# HISTORIC AND DESIGN REVIEW COMMISSION

January 17, 2024

**HDRC CASE NO:** 2024-010  
**ADDRESS:** 517 WICKES  
**LEGAL DESCRIPTION:** NCB 2916 BLK 5 LOT 17  
**ZONING:** RM-4, H  
**CITY COUNCIL DIST.:** 1  
**DISTRICT:** King William Historic District  
**APPLICANT:** FLORES STEPHANIES & JOE MARK  
**OWNER:** FLORES STEPHANIES & JOE MARK  
**TYPE OF WORK:** Driveway modifications  
**APPLICATION RECEIVED:** January 02, 2024  
**60-DAY REVIEW:** March 3, 2024  
**CASE MANAGER:** Claudia Espinosa

1. Widen the existing concrete driveway from 10 feet to 16 feet.
2. Widen the existing concrete driveway apron from 12 feet to 20 feet.

# Survey Picture of Before View

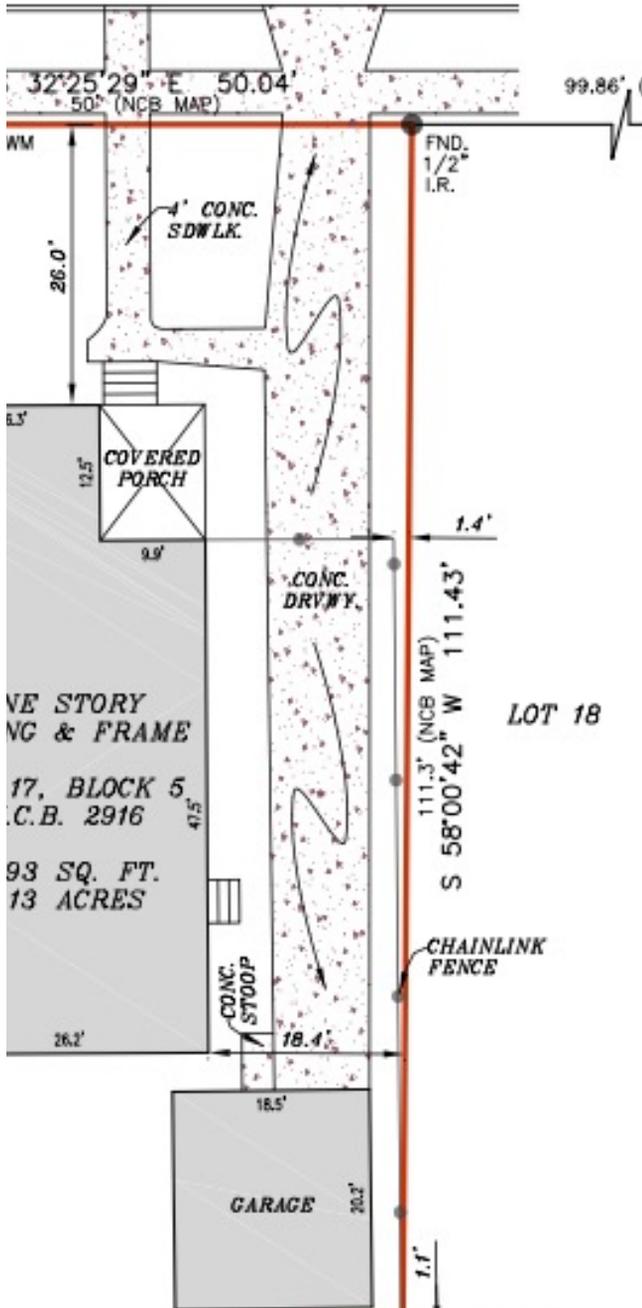
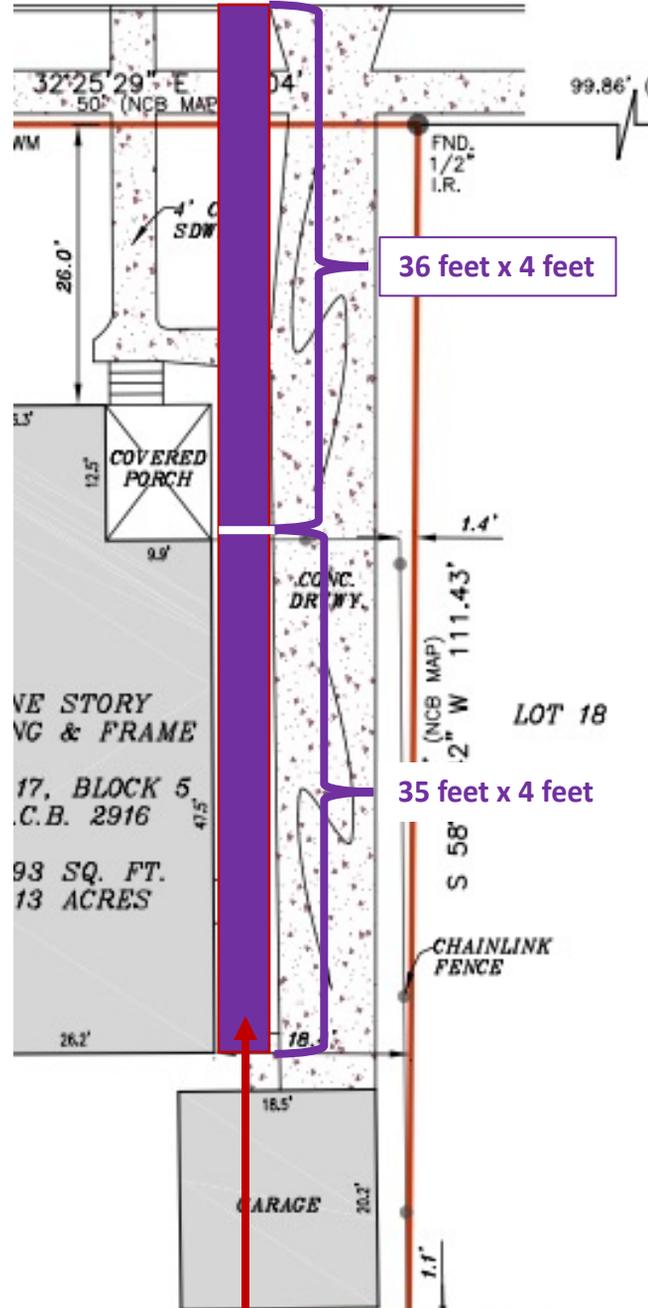
Driveway Widened by 4 feet

# Ramp goes on top of concrete

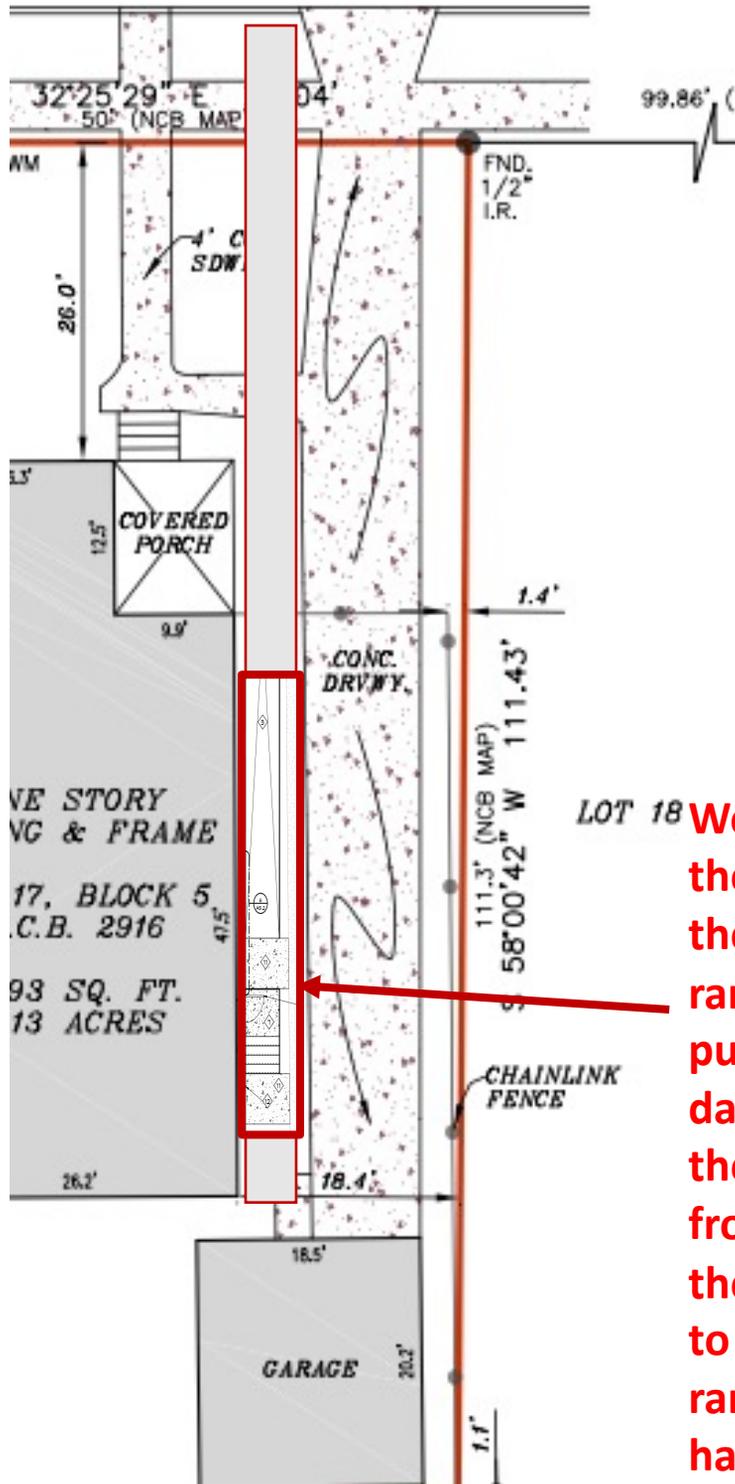
We also went all the way back for the pre-approved ramp we are putting in for our daughter here. So the concrete goes from the front all the way to the back to her wheelchair ramp which we have not built yet.
